**Subject:** RE: Northshore Hamilton - Remora MacArthur Upgrade drawings

**Subject:** Northshore Hamilton - Remora MacArthur Upgrade drawings

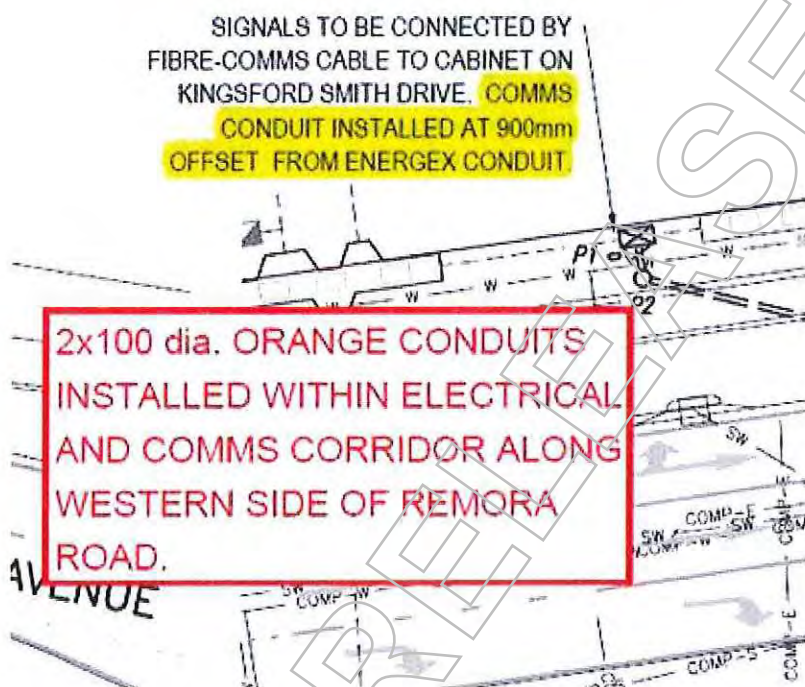
As discussed please find attached early sketch of bus stop on MacArthur Avenue. Can you please provide comment regarding the length and location etc. As discussed I was planning for this stop to ultimately cater for a minimum of 2 buses.

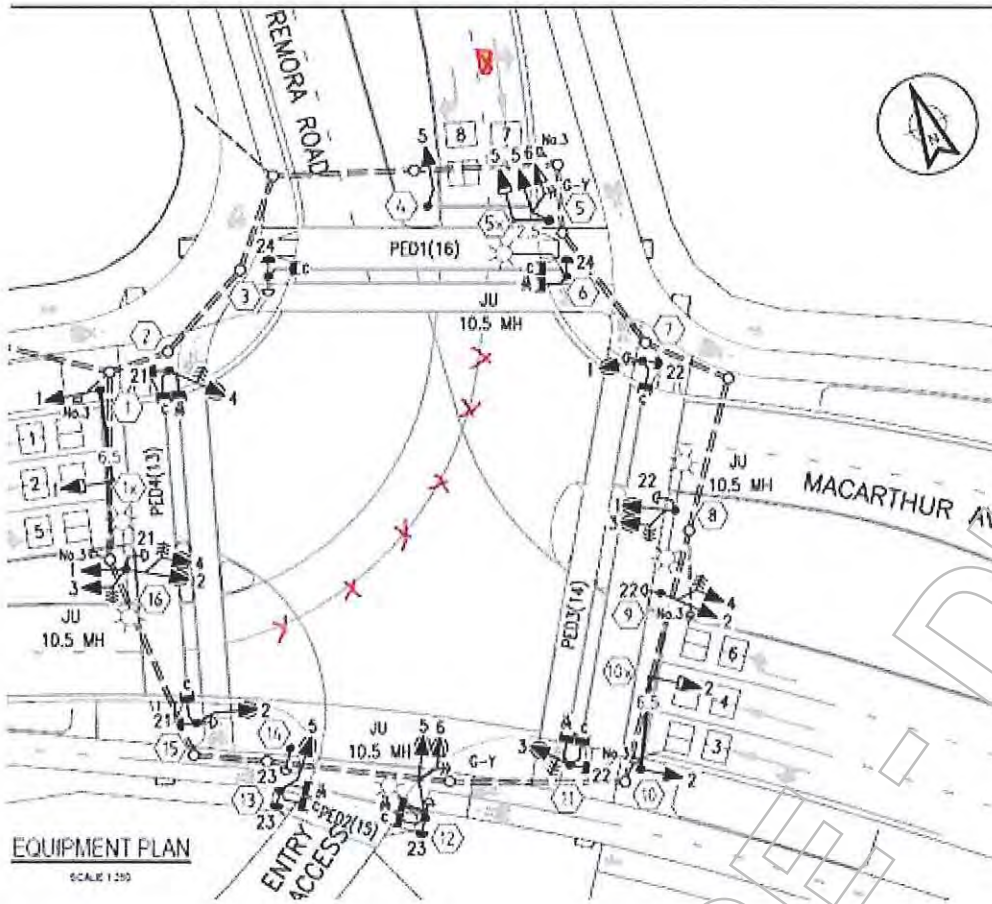
Further to our meeting on Friday regarding the BCC Comms conduits and as requested please find attached a copy of our signals drawings for comment/acceptance.

In regards to the notes for connection, these will be installed as per our discussions last week. The text highlighted yellow below should be changed to something more like the text in red. For the Finnegan Street (this street name will be corrected on the plans) signals the corridor will be on the south side of MacArthur Avenue.

Another minor change which we are looking to adopt which will not affect signal phasing is to remove the right turn movement from the left southbound lane on Remora Road as per the below mark up.

Can you please provide comment at your earliest convenience as well as Site numbers? Once we have these comments and site numbers we will update the plans to 'For Construction' and ready for BCC Traffic Signal Operations sign off then issuing to our contractor onsite.
